Service Bulletin 15

<h1>Service Bulletin</h1>		
1. General		
(a) Service Bulletin No.:	15	
(b) Revision / Date	Revision 0 - 04 Oct 2007	
(b) Title:	Triple and Quadruple Burner Frames -Weld Inspection

(c) Description:	Detailed visual inspection of weld at gimbal bearing (triple burner frame cross bar) and attachment of cross bar to outer frame (triple and quadruple burner frames).

Figure 1

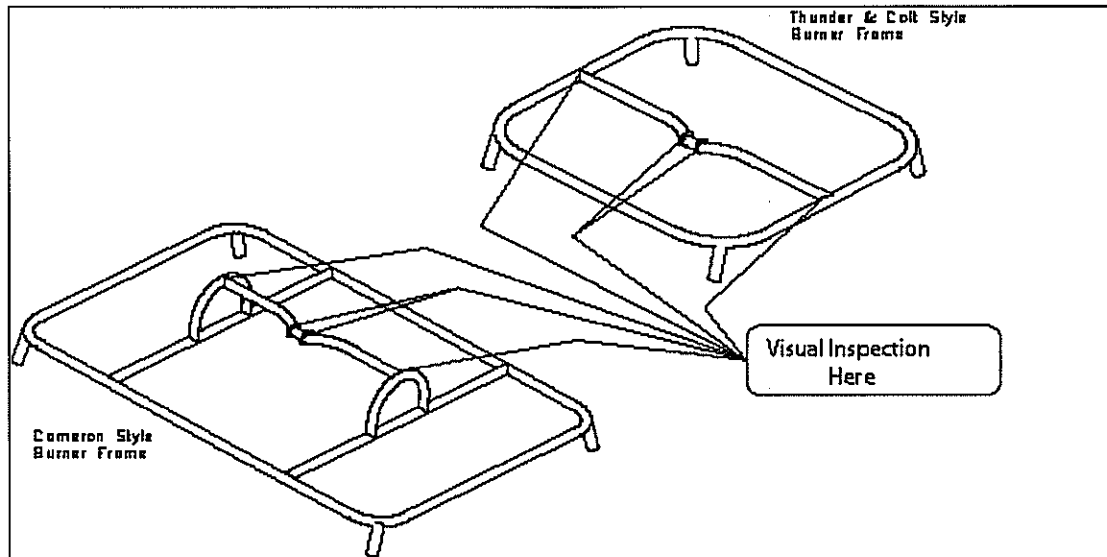
2. Background		
<p>Weld failures have occurred in these frames due to inappropriate ground handling eg repeatedly dropping basket including mounted burner off trailer.</p>

1. Visual inspection through 360° at weld around gimbal bearing (triple burners only) and at attachment of cross bar to bridges on outer frame (triple and quadruple burners). This may be carried out by the pilot. Refer to Figure 1.
2. Remove from service any frame showing signs of cracking.
3. Report any rejections to Cameron Balloons Ltd. (CBL).
4. Cracked burner frames can be returned to service by incorporation of modification C484.
5. Inappropriate ground handling of basket to be discontinued.
